# Process Change Notification

PCN Number: PCN-2016-55

### **STATS ChipPAC\* Assembly, Test and Final Pack Site Transfer from Shanghai to Jiangyin CHINA**

Below is a 2D representative image of the Package: MF (Mark Format) = 246 Rev A

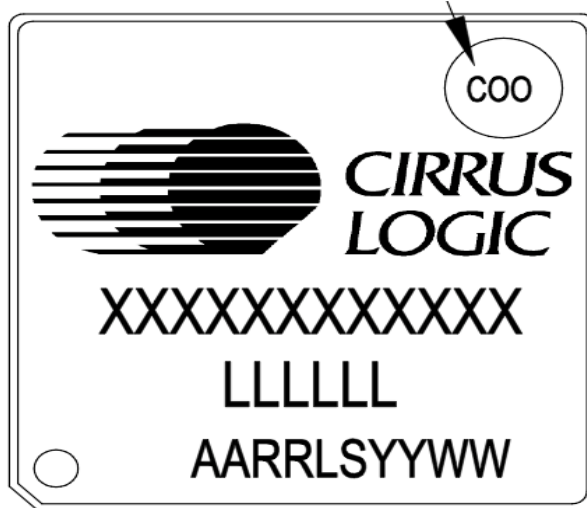
The Cirrus Logic component symbolization on the external face of the device reflects the designated Assembly Site location. The Assembly Site Code on the external face of the designated components will change. Specifically, the 1<sup>st</sup> two characters of the PackMark will change:

From: "BA"  
 To: "BB"  
 Note: All other symbolization will remain the same.
